## WHITE WATER PARK PHASE 2 MODIFICATIONS

## MODIFIED DESIGN

**(1)** 4 Panel Flash Board **Existing Wave** CURRENT (2) Structure CONDITION **③** Fish Ladder **Floater Bypass** (4)

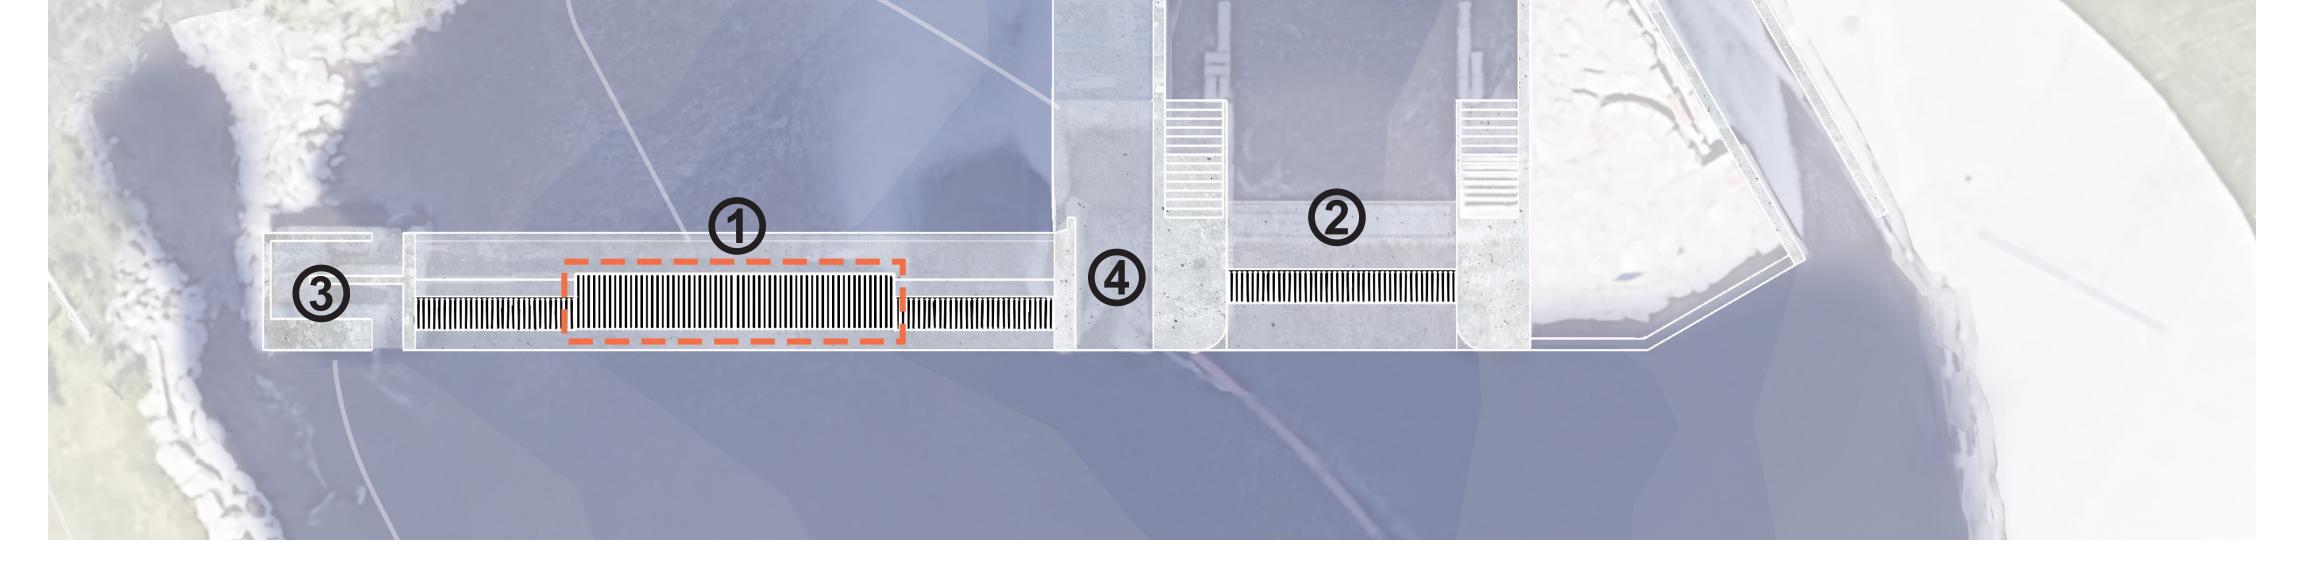
## **6 Panel Flash Board** (1)

- Will allow for more flexibility to modulate wave function based on river flow
- Provides pass through option for stray boaters

## **New Obermeyer Gate** (2)

Meant to provide more consistent and reliable wave shape feature
